## MEMO

**To:** Kristopher Byrd, Well Construction and Compliance Section Manager  
**From:** Travis Kelly, Well Construction Program Coordinator  
**Subject:** Re-Review of Water Right Application G-18903  
**Date:** April 23, 2021

Application # G- 18903-RR

TO: Water Rights Section Date 3/30/2021  
 FROM: Groundwater Section M. Thoma  
 Reviewer's Name  
 SUBJECT: Application G- 18903-RR Supersedes review of 09/16/2020  
 Date of Review(s)

Well Location Maps

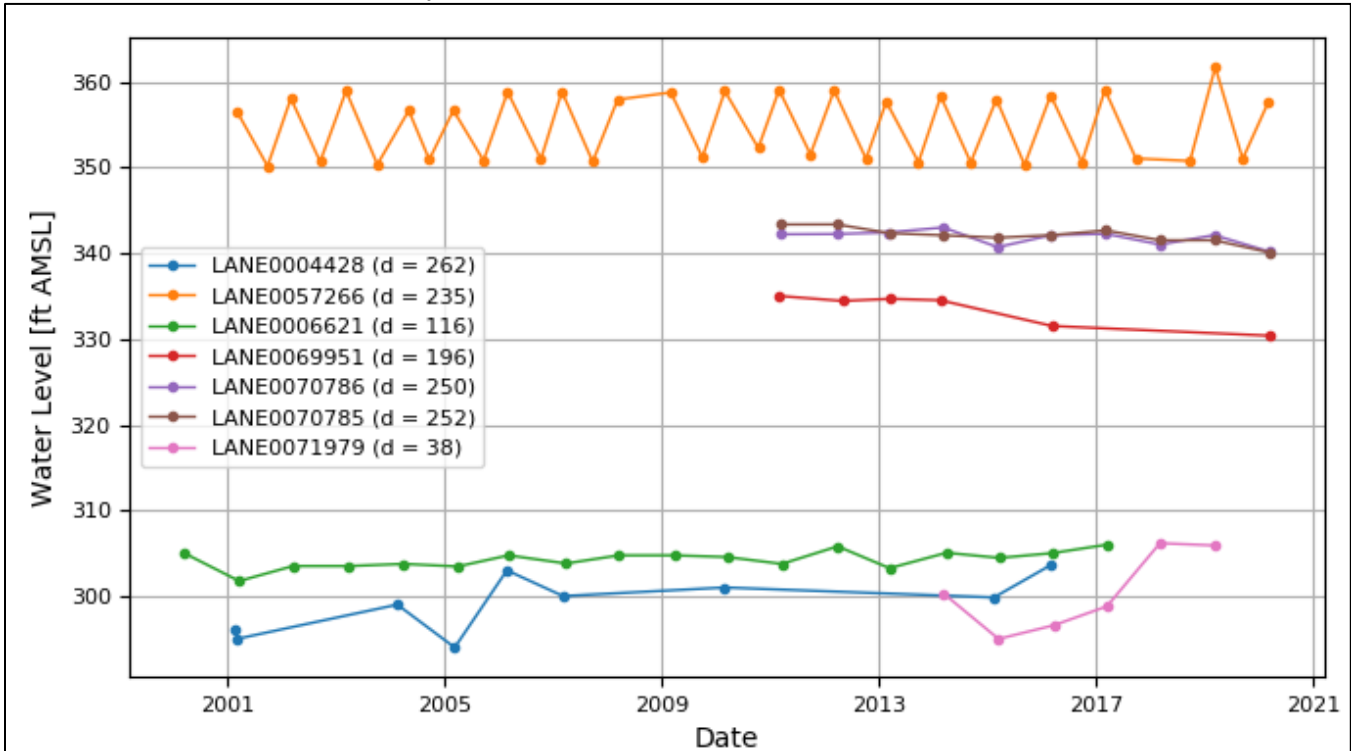
A4. **Comments:** The applicant is proposing Nursery use on 9.0 acres total on three separate tracts of land each in a different PLS section and the proposed POAs themselves are separated by as much as 5 miles. The application lists well-specific rates in Section 3 but a single, maximum rate of 0.125 cfs will be evaluated in this review based on conversations between OWRD and the applicant. The application does not list a proposed depth or source aquifer for any of the wells but this review assumes they will be producing from shallow alluvial material, which is the dominant, productive aquifer in the region. The applicant states that Well #4 and Well #5 are existing but no well logs were provided with the application. \*\*The location latitude and longitude listed on the map for Well #5 does not match with the marked location on the map; the difference is approx. 800 ft and both locations will be reviewed where necessary to determine the maximum potential impact.

**Stream-Depletion Estimates for (A) POA #1 and (B) POA #4. Stream-depletion for POA #2 and POA #5 will be similar to POA #1 and stream-depletion for POA #3 will be similar to POA #4**

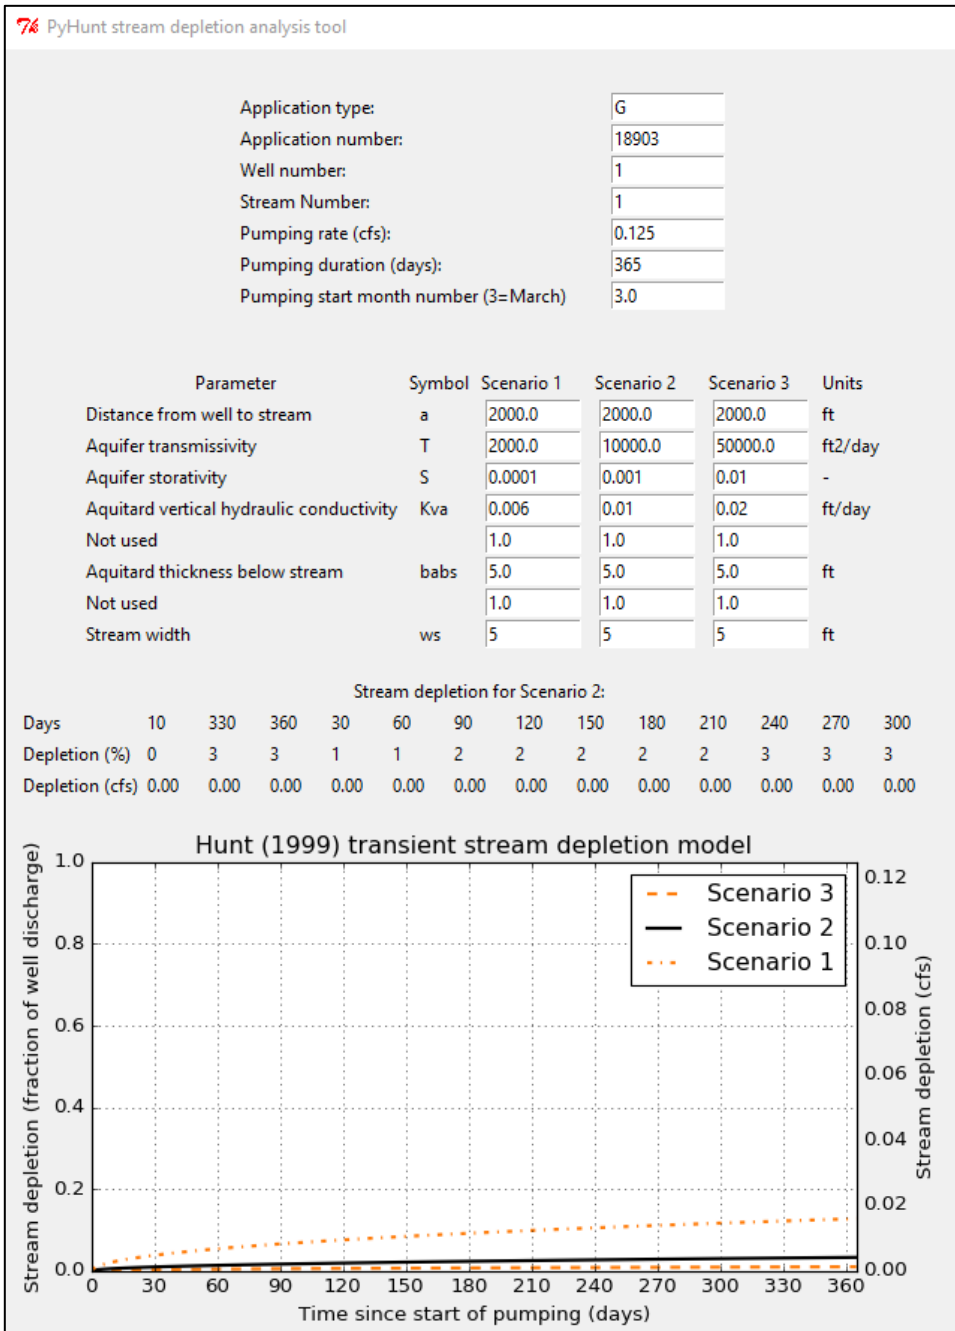
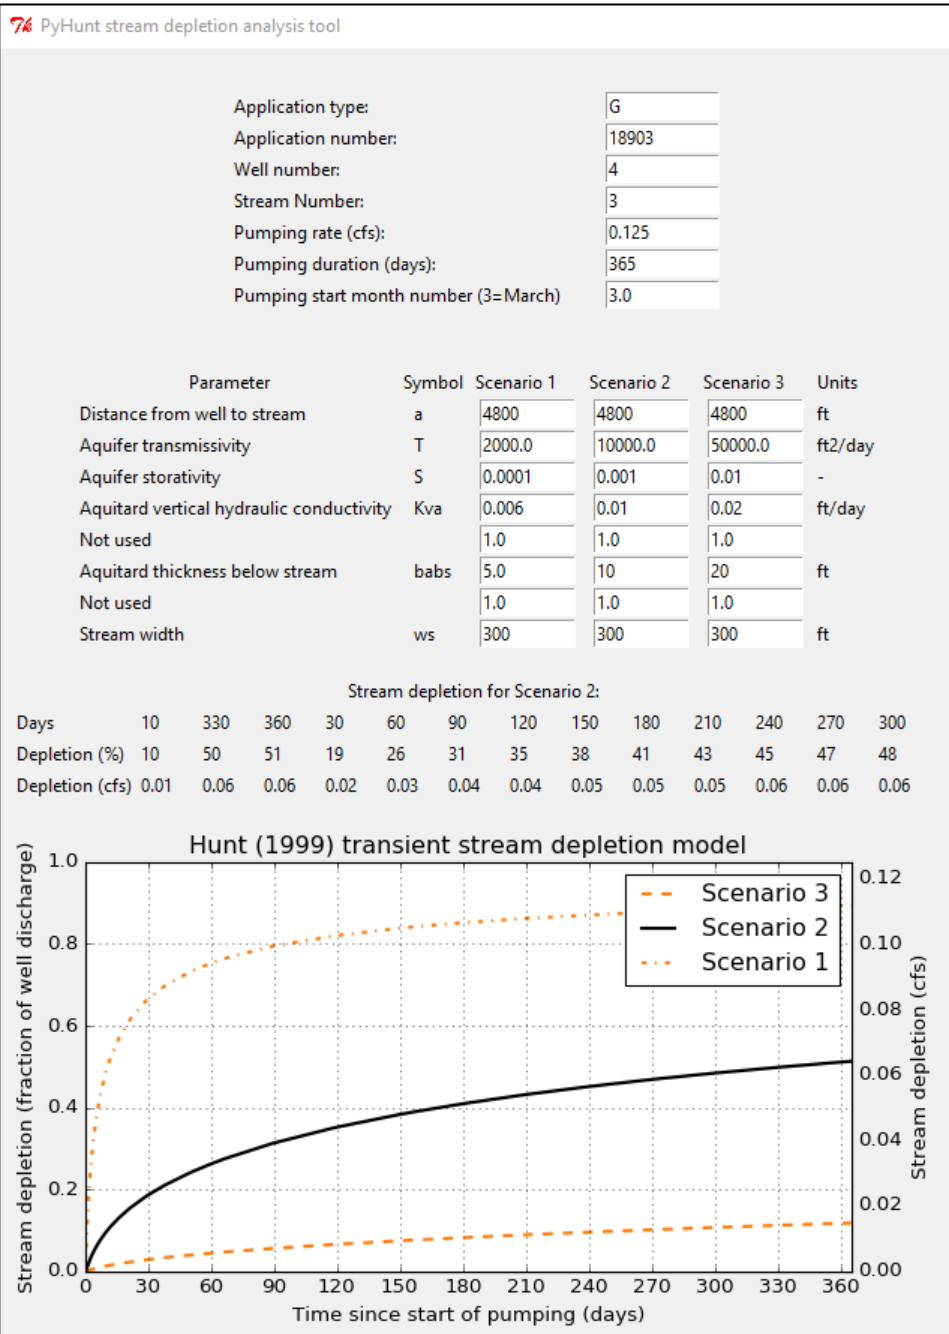
**Comments:** Stream-depletion was estimated using the Hunt-1999 stream-depletion model with model parameters taken from the OWRD Pump Test Database and Herrera et al., (2014). Stream-depletion estimates are shown below.

C6. **SW / GW Remarks and Conditions:** The applicant's proposed POAs would be producing from an aquifer system that is unconfined and found to be hydraulically-connected to surface water – specifically tributaries to the Willamette River. The distance between the POAs and surface water is less than 1 mile for 4 of 5 of the proposed POAs. Stream-depletion estimates using the Hunt-1999 model estimated that interference to surface water any of the proposed POAs is not likely to result in the Potential for Substantial Interference per OAR 690-009.
